TECHNICAL BULLETIN

[Issue No.] T09-0020

[Title] Upgraded functions of the MELSEC-Q series Ethernet interface modules

[Relevant Models] QJ71E71-100, QJ71E71-B5, QJ71E71-B2

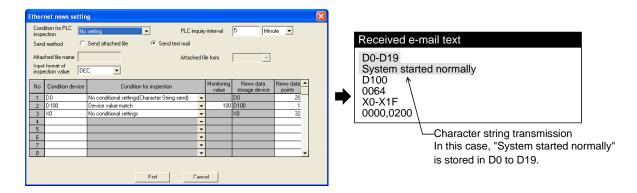
*1 The flow of the command and response messages in the 4E frame is as follows:

- The structure containing the header and text (command) or text (response) is the same as that of the QnA compatible 3E frame.
- For consecutive transmission of multiple command messages from the external device, there are restrictions on the number of the command messages that the Ethernet interface module can receive.
 Please refer to the Q Corresponding MELSEC Communication Protocol Reference Manual (SH-080008) for the restrictions.
